Access Compliance Report Public Rights-of-Way (Curb Ramps)

Main Street: WOODSONG Cross Street: CASTLETREE Location: E

ADA ID: RPRK211018144930 Ramp Type: Type 1 - Perpendicular Diagonal Initial Pass/Fail: Fail Overall Compliance: No Severity Score: 16

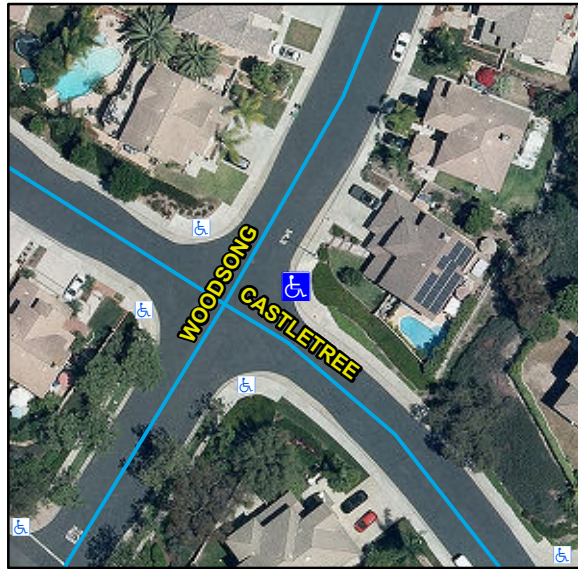
R204.3, R304.2.2, R302.7.2, STD 1115

Remove & Replace Curb Ramp With Two New Directional Ramps or Equivalent. Grind Gutter Lip.
